RE: 2018CCI030 – Parramatta – DA/868/2018 – 164 Hawkesbury Road, Westmead 2145

This letter has been prepared by Ethos Urban on behalf of Western Sydney University (WSU) being the Applicant of DA/868/2018 at 164 Hawkesbury Road, Westmead. This DA is to be determined at the Sydney Central City Planning meeting scheduled for 4 December 2019.

We refer to the Draft Conditions prepared in relation to this development. Whilst WSU has worked with Council officers to agree on the majority of conditions, the applicant and Council did not reach agreement on the imposition of Condition No .40(q). Of key concern is the wording of draft Condition 40(q), set out below in **bold**:

Figure 1: Ground Plan Extract

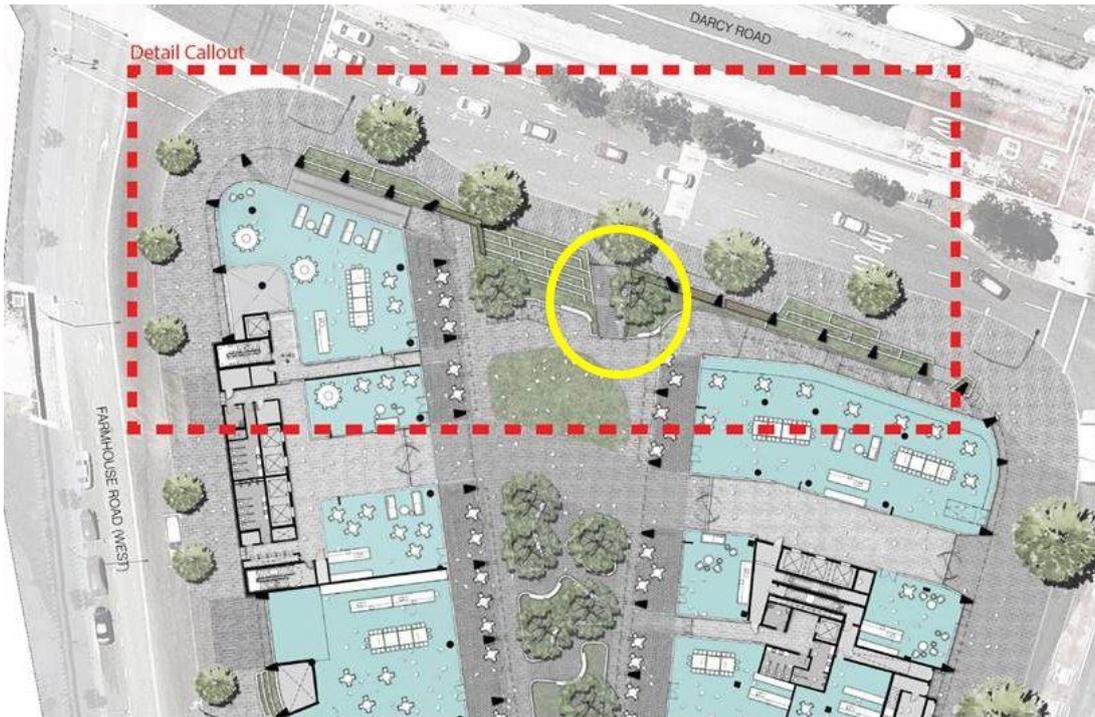
q) The mid-block stairs and tiered concrete retaining walls with mass planting should be more generous in width and depth offering gradual accent, more rest points, open up the visual connection, and is more inviting and supports 24/7 public access between Darcy Road, the central space and Farmhouse Road South;

The applicant requests that the panel delete this condition as significant design work and coordination has been undertaken to develop the appropriate design solution for the mid-block stairs, including sign off from the Design Excellence Advisory Panel (DEAP). The wording of the condition is problematic for the Applicant as it creates uncertainty as to how the condition is to be satisfied and may potentially hold up the issue of the relevant Construction Certificate (CC). The condition as currently drafted may require significant design changes which may also have a significant cumulative impact on the design due the 4.25m² height difference between the street and proposed plaza.

The mid-block stairs are unlikely to be the primary access point to the site from Darcy Road as there is no pedestrian crossing at this location. The main pedestrian desire line to and from the hospital through the plaza is at the north-west corner of the site where the majority of pedestrian movements will occur, being the junction of the road intersection leading to the hospital and the proposed escalators to the plaza.

Accordingly, it is requested that Draft Condition 40(q) is deleted. Any required change to this mid-block stair configuration will significantly impact a number of coordinated elements of the design at this part of the site which is already dealing with a significant level change. In the context of the DEAP having already considered a detailed response on this issue and supported the applicant's justification, it is considered that this draft condition is not reasonable and is therefore requested to be deleted.
